ATTENTION:GENERAL MANAGERIPARTS MANAGERICLAIMS PERSONNELISERVICE MANAGERI	IMPORTANT - All Service Personnel Should Read and Initial in the boxes provided, right. © 2018 Subaru of America, Inc. All rights reserved.	QUALITY DRIVEN® SERVICE
₩.M	SERVICE BULLETIN	
APPLICABILITY:	2015-2018MY Legacy and Outback 2012-2018MY Impreza 2013-2018MY Crosstrek 2014-2018MY Forester 2015-2018MY WRX	NUMBER: 16-112-18R DATE: 03/15/18 REVISED: 08/14/23
SUBJECT:	Ignition Key Sticking / Design Change to Shifter / Selector Lever Components	CVT

This bulletin announces a design change to the CVT select lever (shifter) mechanism in response to isolated customer concerns of not being able to remove the key from the ignition switch when the vehicle is in Park. The cause is contamination of the Park-Range switch internal components.

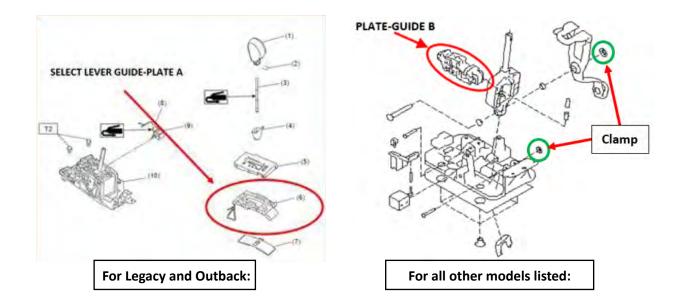
- The term PLATE-GUIDE B refers to the Park-Range switch which is a serviceable part of the select lever assembly on all models listed above **<u>EXCEPT</u>** Legacy and Outback. See the illustrations provided below for more details.
- For Legacy and Outback, the guide plate (GUIDE-PLATE A) must be replaced if the Park-Range switch is found to be faulty.
